TECHedition

Topic : NEW Z5 FEEDER FOR TA MODEL
TEC edition No : TEC/E/004/2012
Date issued : 7th September, 2012
DESRPTION : Z5 FEEDER

Old Type of TA WIRE FEEDER

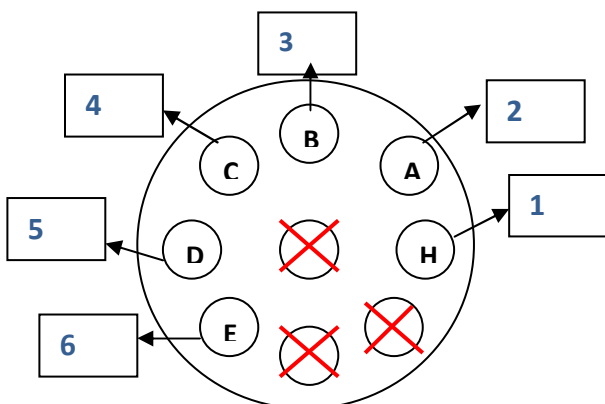
THE CHANGES FOR Z5 FEEDER 9 pin to 6 pin connection

SOCKET		CABLE
H	→	1
A	→	2
B	→	3
C	→	4
D	→	5
E	→	6

Effective Date : ALL NEW ORDERS WILL FEATURE WITH NEW Z5 FEEDER
